Inspection Photos

Operator: GUNNISON ENERGY LLC - 10515

Location ID: 412922

COGCC

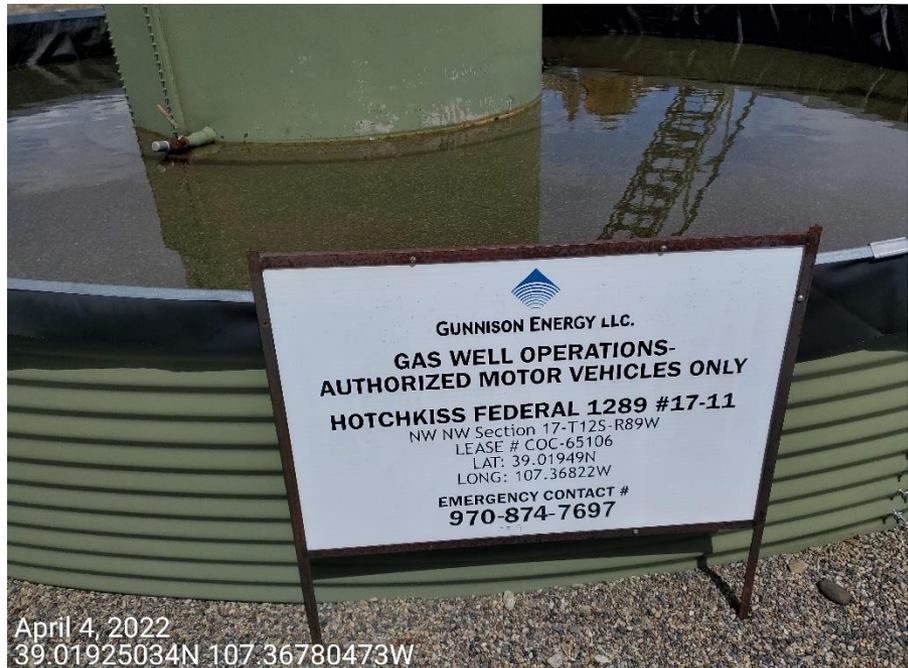
Photo 6: Signage at tank battery remains inadequate; sign missing information per Rule 605.e.. EMS# or 911, Nearest public road, and API. First letter of tank contents on side of the tank remains missing.
